No. 213

Investigation of Potential Geologic Hazards near the Thistle Landslide, Utah County, Utah

Grant C. Willis

Utah Geological and Mineral Survey
February, 1987

Figure 1. Witkind's (1986) Plate I with index map of the Thistle landslide area, geologic map, and cross section A-A'. I have added the proposed trench locations to explore the Thistle Canyon fault(?) and proposed drill holes to investigate the questioned Thistle Creek diapir.

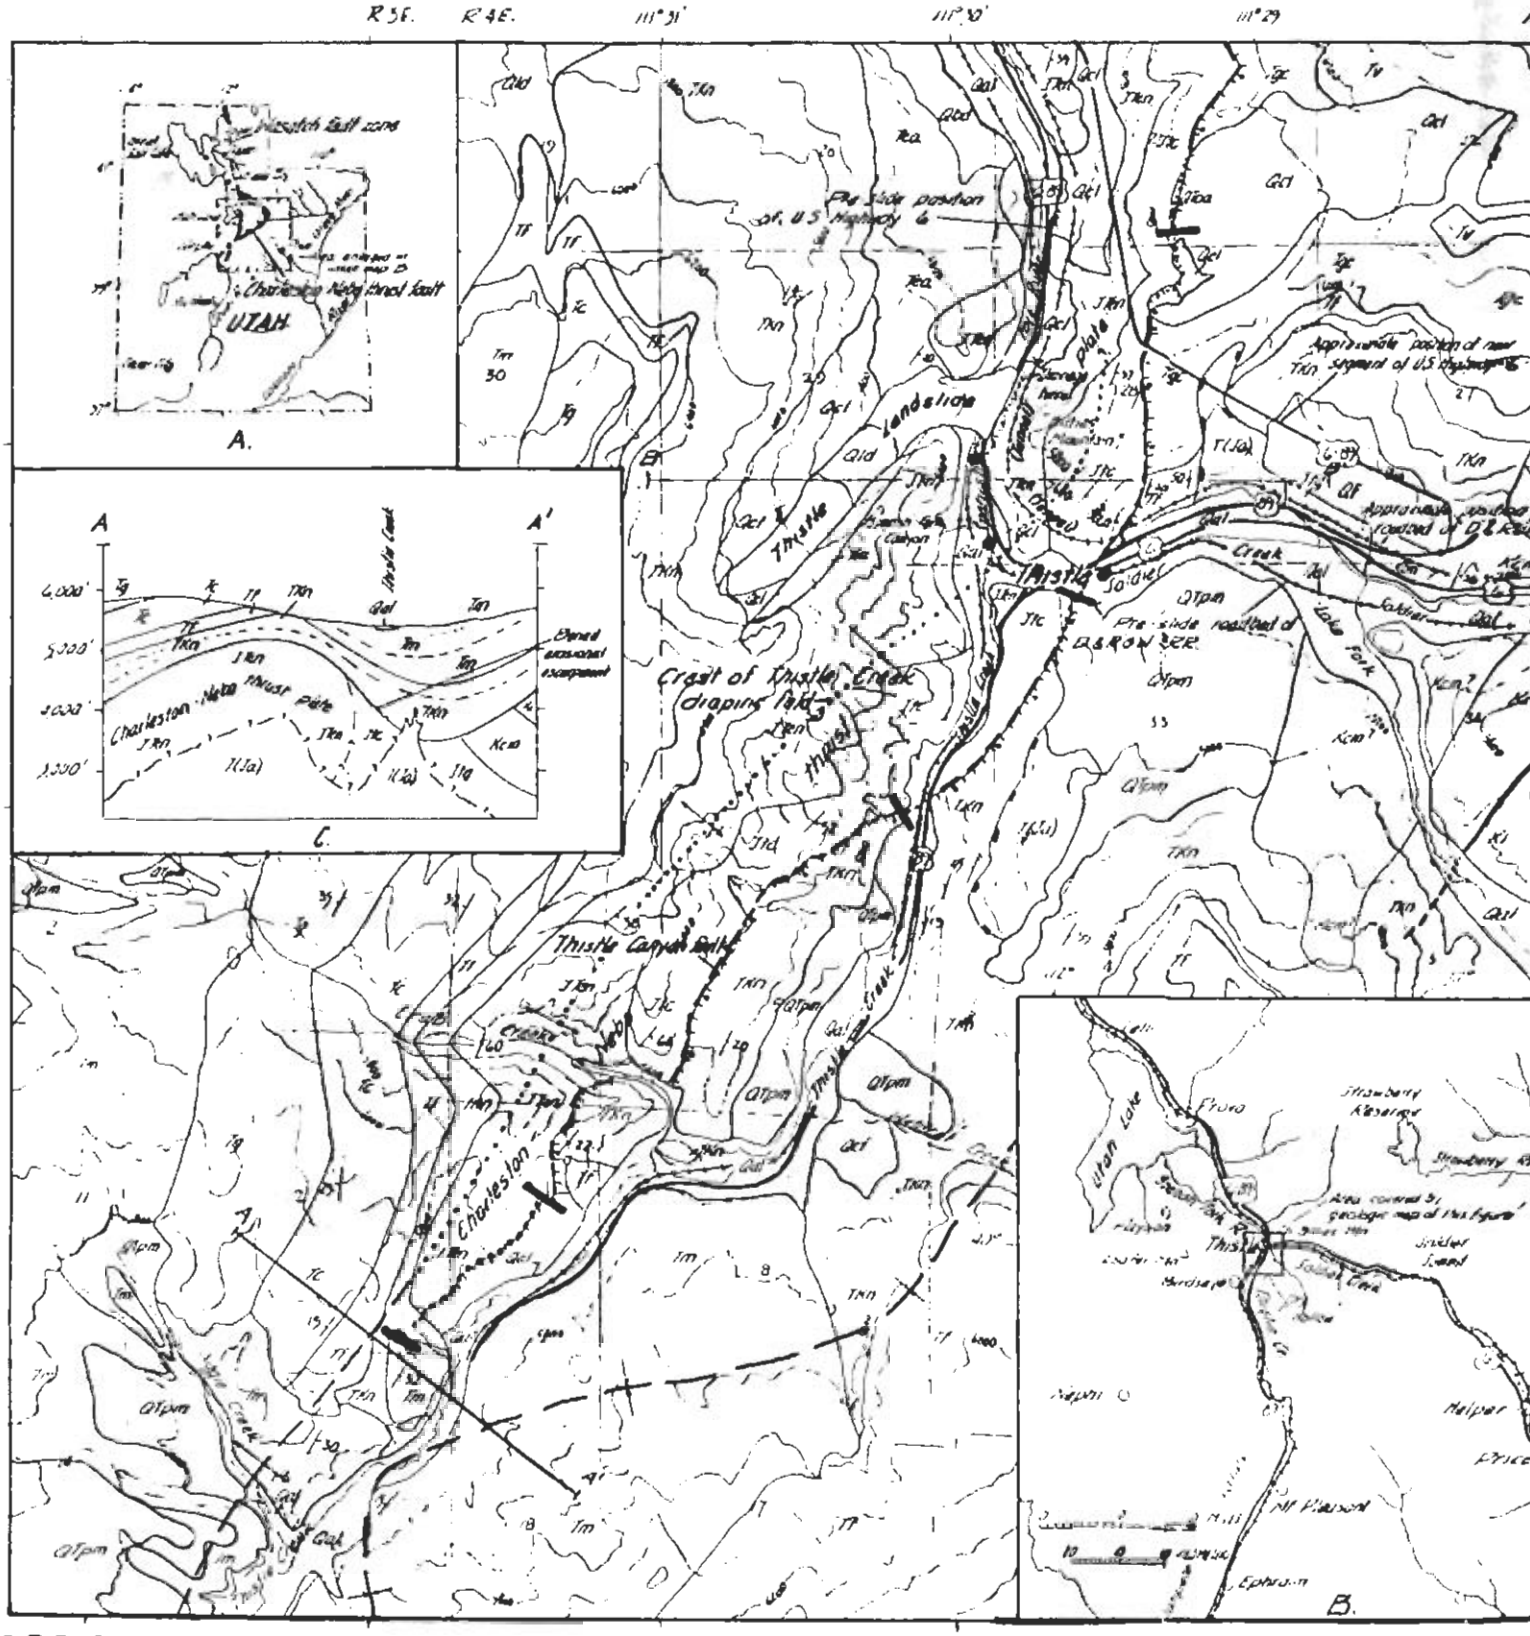
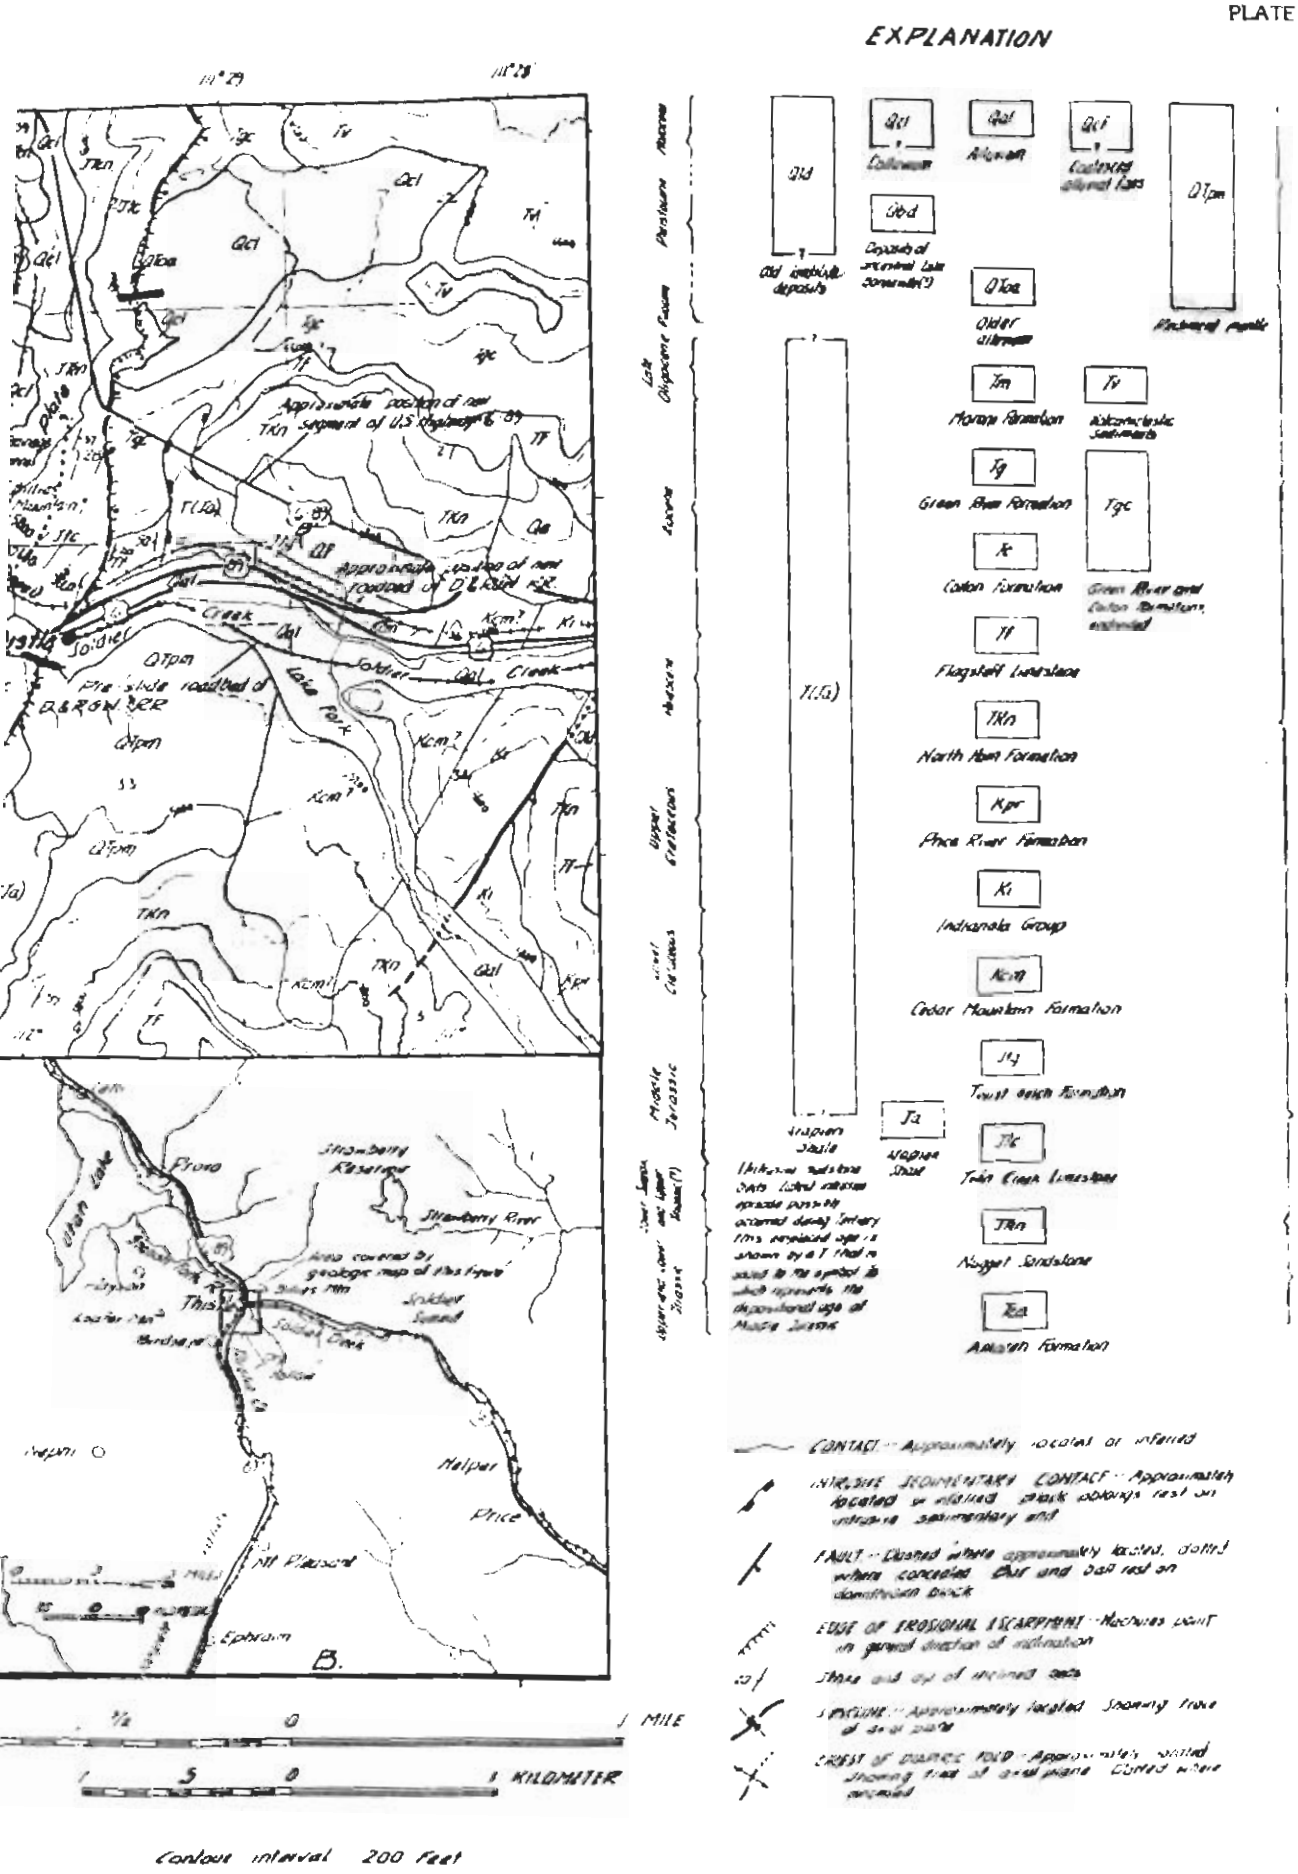
I attempted to examine the fault(?) in other places along Thistle Creek. In the places I examined I found the critical contact to be too covered to aid in the interpretation. I do believe the contact could be exposed in some places by shallow trenching or stripping of surficial cover (figure 1). A critical place to attempt this would be just south of the last place Witkind mapped the fault in the southwest corner of his map. He stops the fault just before it cuts any of the Moroni Formation. Since the Moroni is the youngest bedrock unit in the area it would be valuable to know if the fault cuts the formation, is covered by it, or if the fault extends that far south. The fault does seem to decrease in offset toward the south. In the southwest part of Witkind's map, outcrops of the Flagstaff Formation on both sides of the fault trend could be projected so as to join without the need of a significant fault. Thus this trench alone would not be conclusive but it could be helpful. Other proposed trench sites are shown on figure 1.

Witkind shows on his map (figure 1) a diapiric feature located east of the "Billies Mountain" road cut which has its top exposed at the surface. Witkind (1986, p. 10) gives two interpretations of this feature: "(1) the mass of disturbed Arapien may be strata [from the underlying thrust plate] that punched up through Arapien beds that were part of the [Charleston-Nebo] plate, or (2) they may be integral elements of the Arapien within the [Charleston-Nebo] thrust plate that became mobile and then deformed the overlying strata." Witkind prefers the first interpretation, believing that it better fits his

The position of the Charleston-Nebo thrust fault is important in the study of this issue. A comparison of Witkind's cross section A-A' (inset on figure 1) and Baker's cross section C-C' (figure 10), which is projected from about 9 miles (14 km) to the north, illustrates some significant differences. Witkind places the thrust fault in the subsurface at about 3000 feet (900 m) elevation (about 2000 feet, 600 m below the surface) with allochthonous Navajo Sandstone over autochthonous Arapien Shale.

-Dig several "backhoe" trenches across the possible fault. Five localities are proposed here and are shown on figure 1. One trench would attempt to expose the fault in the Moroni Formation in the south end of the area; one would attempt to expose it in bedrock between the Flagstaff or North Horn Formation and the Navajo Sandstone; and three of the trenches would attempt to determine if the fault has cut any surficial deposits. If the fault is related to diapirism this could aid in determining if there has been any recent diapiric movement. It is realized that the trenches

-If additional investigation is deemed necessary, I suggest drilling up to four deep holes in the bottom of the canyon through the Navajo Sandstone and Twin Creek Limestone. Recommended locations are shown on figure 1. Based on Witkind's cross section B-B' the holes would need to penetrate between 1000 and 2000 feet (300-600 m) of rock (figure 2B). However, if my cross section is more accurate then it would require drilling about 5000 feet (1500 m) (figure 9). The eastern-most hole would also aid in evaluating the subsurface configuration of the Thistle Canyon fault(?).

Figure 2. Witkind's (1986) figures 3A and 3B showing two possible interpretations of cross section B-B' shown on figure 1. Witkind prefers option B.

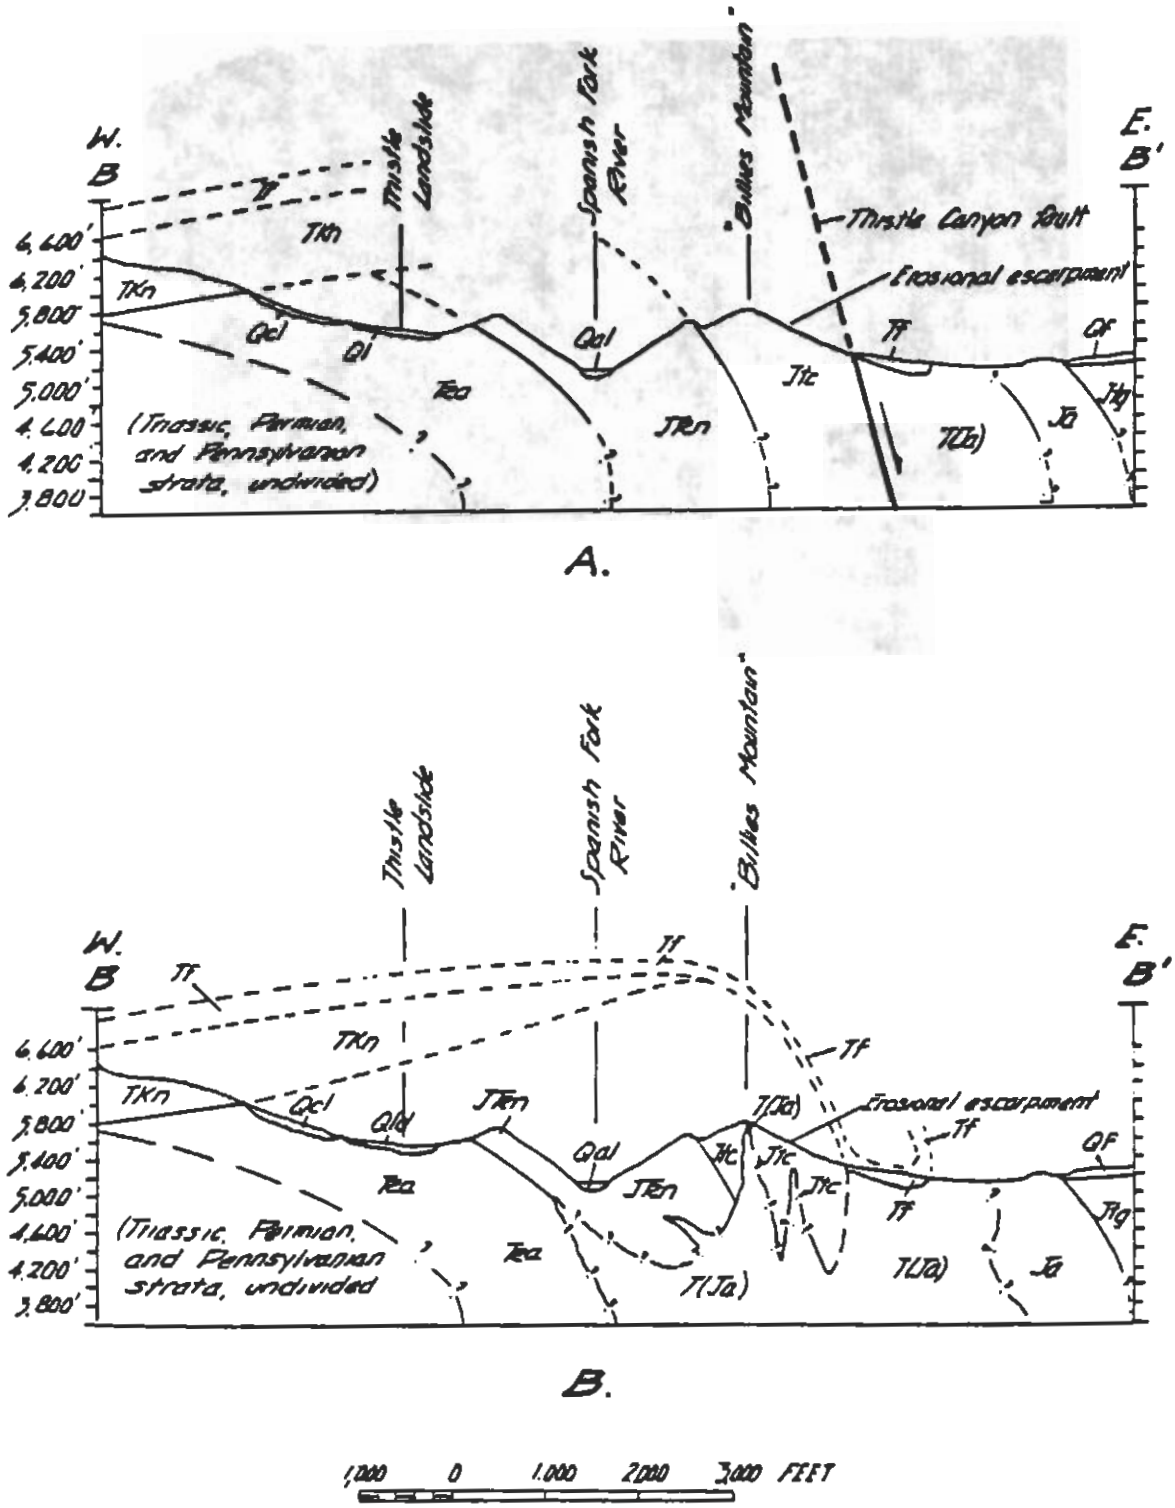
Witkind does not believe the fault exists. He instead explains the offset Tertiary beds by the presence of an asymmetric anticline which was formed by a rising diapiric mass of Jurassic Arapien Shale (figure 2B). A question mark (?) is hereafter used in this report when referring to the Thistle Canyon fault to indicate its questionable existence.

Witkind believes that the proposed asymmetric anticline used to explain the offset Tertiary beds was caused by diapirism of underlying Jurassic evaporites (figure 2B). Geologically, a diapir is a mass of salt, gypsum, anhydrite, mudstone and/or other low-density material that rises slowly, penetrating through or bowing up overlying rock, similar to the way oil will rise through water and due to a lower relative density. Rate of movement can vary greatly. Witkind's main evidence stems from westward-tilted Tertiary beds on the west side of the anticlinal axis, eastward-tilted beds on the east side, possible thinning of the North Horn Formation through Green River Formation over the crest of the fold, and possible intruded evaporites that were exposed in the road cut in "Billies Mountain." If the diapir is present its axis would trend approximately under the proposed dam site. I interpret Witkind's concerns to include the following: 1) if the diapir is actively rising, it could disrupt dam fill over a period of time, 2) a change in ground-water characteristics caused by the reservoir might result in dissolution of evaporites and cause subsidence or collapse of the overlying rock and dam fill, 3) an overlying body of water might upset the isostatic balance and increase or renew diapirism, and 4) it raises doubt as to the stability of the rock foundation on which the dam might be built.

In the eastern part of his cross section B-B' (my figure 2B) Witkind shows the Flagstaff as deposited directly on the Arapien Shale. This differs from his earlier map (Witkind and Page, 1983) and is based on an exposure near the east portal of the railroad tunnels in the SE 1/4, section 28 (I.J. Witkind, personal commun., 1986). There the Flagstaff is deposited on rock of questionable identity which Witkind believes may be Arapien. However I believe this rock is North Horn Formation as indicated on Witkind's earlier map and the map by Baker (1976) (figure 7) (Baker uses the term "Price River Formation" but indicates in his text that the upper part of the Price River may be equivalent to the North Horn Formation). This question could probably be resolved with a palynology study of the outcrop. If the Flagstaff was deposited directly on the Arapien Shale then the Arapien must have been high enough to protrude through the North Horn at the time of deposition of the Flagstaff. If the Arapien Shale protruded through the North Horn Formation at the time of deposition of the Flagstaff Formation, it likely did so because of diapirism since rock of the Arapien Shale is not resistant enough to remain high through all of North Horn time.

Witkind (p. 11) postulates an amplitude for the possible diapiric fold of about 1200 feet (365 m) (figure 2B). This is based on the elevation of the Flagstaff west of the fold (6500 feet, 1950 m) and a block of Flagstaff a few hundred feet long east of the fold axis near the east railroad portal (5300 feet, 1590 m). However the Flagstaff near the tunnel is dropped down from

Flagstaff located farther east. Less deformed Flagstaff a few hundred feet to the east occurs at an elevation of about 6000 feet (1800 m). If the fold is projected between the less deformed Flagstaff strata, it permits a fold with an amplitude of only about 500 feet (150 m) which is more symmetric. Figure 9 shows this interpretation. It is probable that the lower Flagstaff block is dropped down by a fault on the east as shown by Baker (1976) and/or by sag due to the Thistle Canyon fault(?) located just to the west. If the Thistle Canyon fault(?) is imbricate in the subsurface then sag would be a likely result. It may also be due to differential movement of the previously discussed smaller diapir. If the fold is more symmetric and has a smaller amplitude, as I propose, it would imply much less diapiric uplift than proposed by Witkind.

I believe Baker's cross section is more correct in that the thrust fault occurs at an elevation of 0 to 1000 feet (0-300 m). I have adapted Witkind's cross section to indicate my view on the position of the thrust plate (figure 9).
Seismic and drill hole evidence suggests that the thrust is deeper than indicated by Witkind (D. A. Sprinkel, 1986, personal communication). The thrust fault is probably underlain by Arapien Shale as indicated by Witkind. If my interpretation is correct then any Arapien underlying the Navajo Sandstone is much deeper than indicated by Witkind in his cross section B-B' (figure 2B). Thus if the diapir is present, I believe it would also be much deeper.

In his cross section B-B' Witkind shows large amounts of Navajo Sandstone and Twin Creek Limestone to be displaced or replaced by Arapien Shale (figure 2B). I do not believe this is a likely relationship. At the surface the Navajo and Twin Creek are in their proper stratigraphic positions and, although fractured, they are not significantly deformed. Thus, if large amounts of these formations have been displaced in the subsurface, they must have been pushed out horizontally. I do not believe this is possible for diapirism which is controlled by gravity and is primarily a vertically directed force. Even if the Charleston-Nebo thrust fault is immediately below the line of his cross section it would still require the unlikely horizontal displacement of large masses of Navajo Sandstone. In addition, seismic and drill data suggest that

Figure 8. Witkind's (1986) figures 2C (A) and 2D (B) showing features he believes are diapiric. Note that the possible diapiric material appears to be limestone or mudstone in (A). I believe the feature in (B) is due to a fault and is not diapiric.

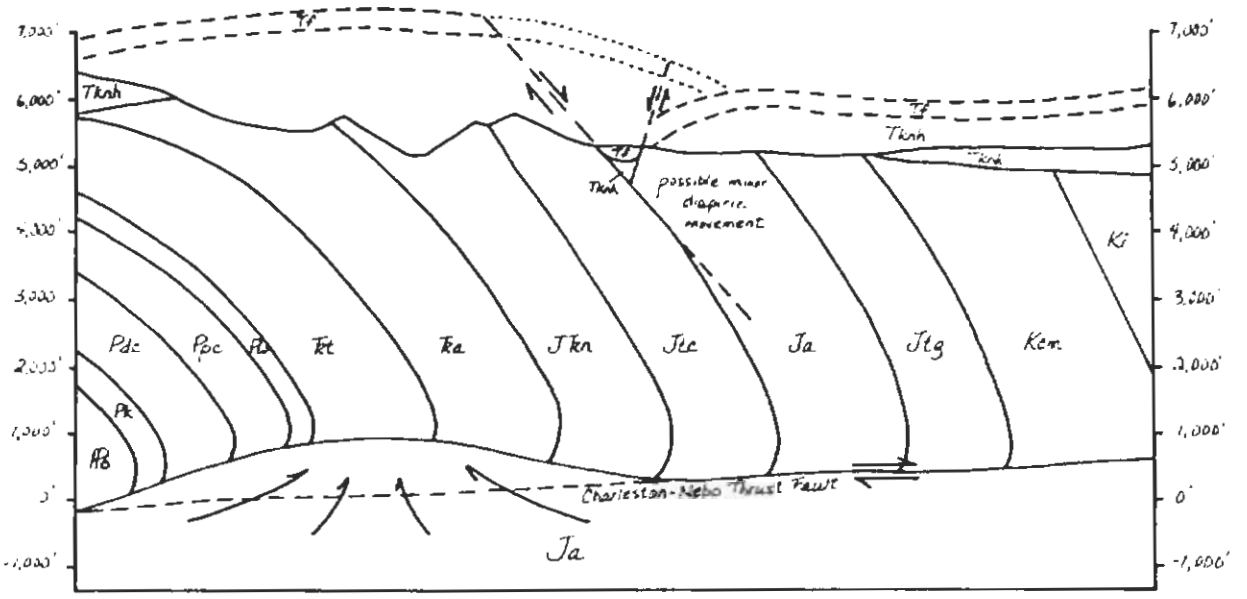
Witkind also sites fingers or wedges of Arapien Shale in the Twin Creek Limestone as evidence of his diapiric model. The best example of these is shown in a photograph in Witkind's report (figure 8A). The outcrop in the photograph was subsequently destroyed by highway construction. The exposure is only a short distance from the proper stratigraphic position of the Arapien Shale. The wedges of Arapien could have been forced into this position during Cretaceous thrusting or by later small-scale diapirism of the overlying mass. In another possibility, the wedge-shaped mass in the photograph may be from the Twin Creek itself rather than the Arapien. Thus I believe this evidence is inconclusive, not supporting any theory.

Near the Thistle Canyon fault(?) Witkind shows another possible diapiric mass of Arapien Shale (figure 8B). The outcrop was altered by subsequent widening of the roadcut since this photograph was taken but the principle features are still present. I do not believe this is a diapiric mass. The proposed intrusive mass occurs at the top of the Twin Creek Limestone and is either the uppermost member of the Twin Creek (Watton Canyon member) or the lower part of the Arapien Shale. The mass is not significantly deformed. The deformation that does occur can be explained by Cretaceous thrusting or by later movement from a fault that occurs in the right part of the photograph. In either case the mass is in its proper stratigraphic position and does not require diapirism or any other structural event to explain its presence.

Another important consideration is the composition of the possible diapiric material. One of Witkind's photographs is particularly significant (figure 8A). Although the outcrop shown is now destroyed, the intruded(?) material appears to be mudstone or limestone and not gypsum. In other places in central Utah the diapiric material is probably primarily mudstone while evaporites are a minor constituent of the mudstone. Witkind on the other hand believes that evaporites are the primariy diapiric unit and that mudstone only forms a passive sheath (Witkind, 1982). I believe this question would be of particular significance from an engineering standpoint.
